**Record of Decision for Remedial Action
for the Quarry Residuals Operable Unit
at the Weldon Spring Site,
Weldon Spring, Missouri**

September 1998

U.S. Department of Energy, Oak Ridge Operations Office, Weldon Spring Site Remedial Action Project, Weldon Spring, Missouri

FIGURE 7 Areas with Suspected Contamination to be Fully Characterized during Quarry Restoration

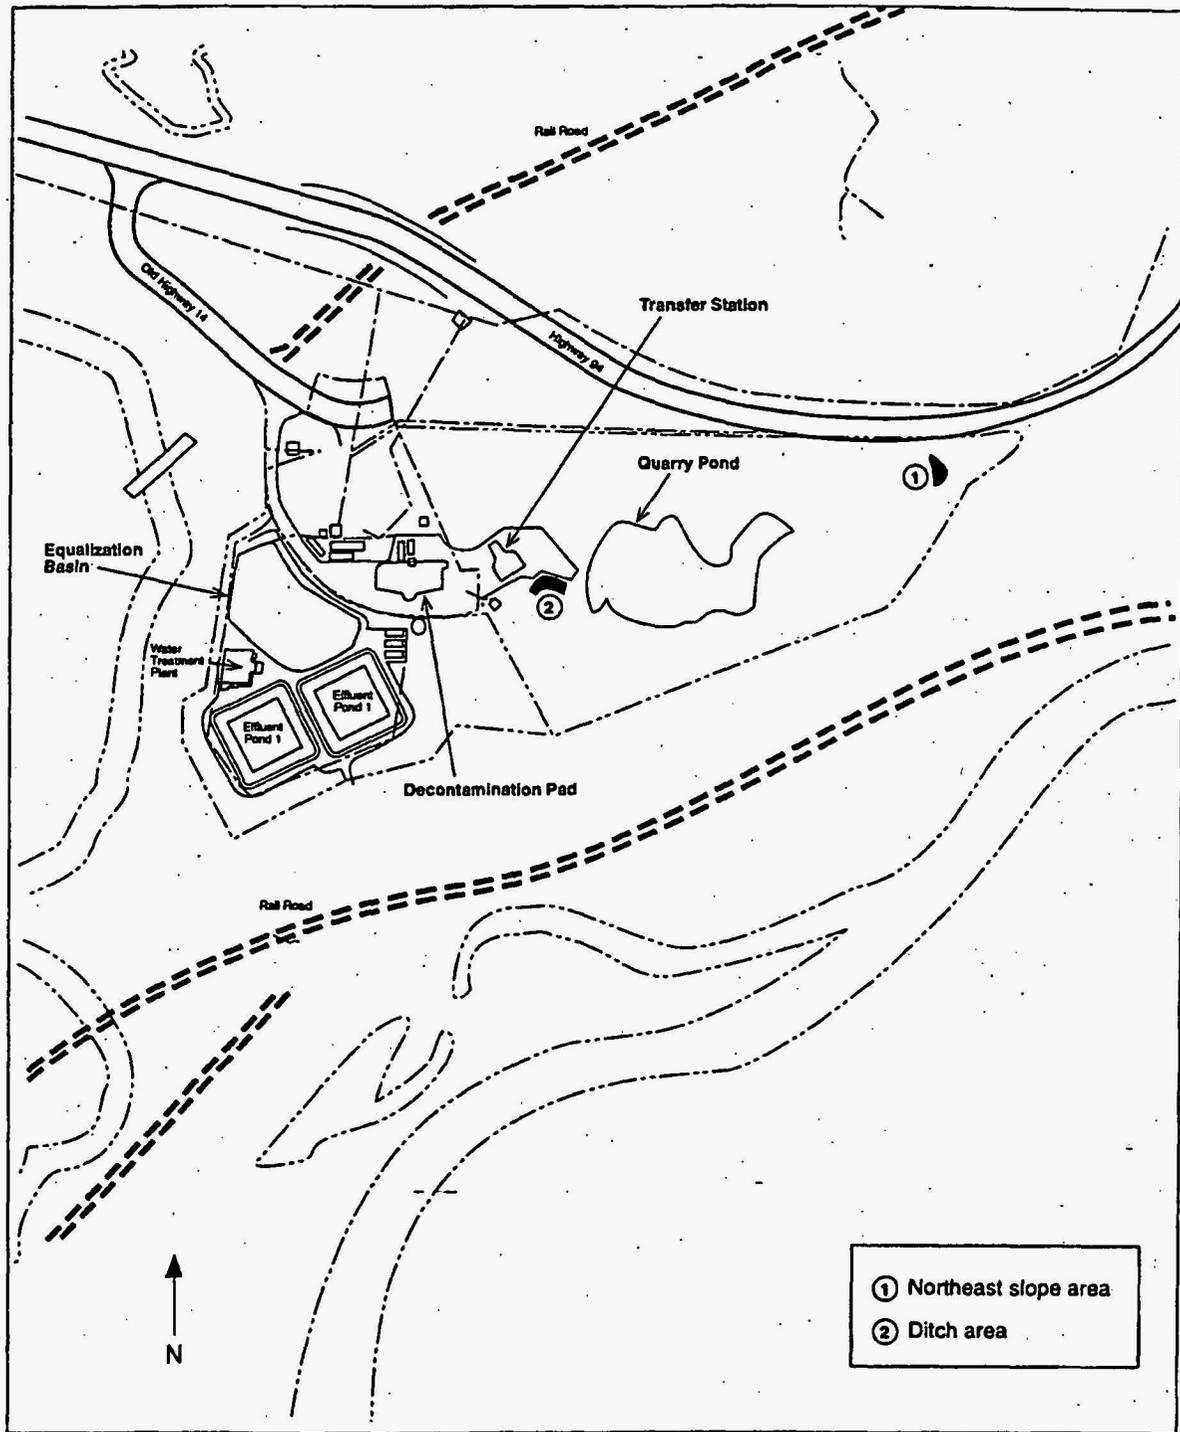
At the quarry proper, additional sampling is planned at the northeast slope and the ditch area near the transfer station (see Figure 7). Only a few samples were collected from these two areas during the RI phase because access was difficult. The samples collected indicate the presence of radiological contamination; however, additional samples need to be collected to sufficiently define the extent of contamination. Risk calculations will be performed consistent with the approach presented in the *Baseline Risk Assessment* report (DOE 1998a), to include these additional data points. If response action is necessary, the cleanup criteria for radionuclides presented in the chemical plant ROD (DOE 1993) will be applied. This response action would involve removal of contaminated soil from the northeast slope and the ditch area. Finally, DOE intends for the extent of any soil removal at the northeast slope to be protective of human health and the environment, but not to include the relocation of State Route 94.

As part of the selected action described in Section 8 of this ROD, the DOE has proposed additional characterization at the northeast slope and drainage ditch area within the quarry proper. These data would then be used to perform risk calculations consistent with the approach presented in the BRA (DOE 1998a) for the QROU. If calculations indicate risks to be greater than the EPA's acceptable risk range of 10^{-6} to 10^{-4} for a recreational scenario, soil removal would be undertaken to meet cleanup criteria presented in the chemical plant ROD (DOE 1993) for radionuclides.
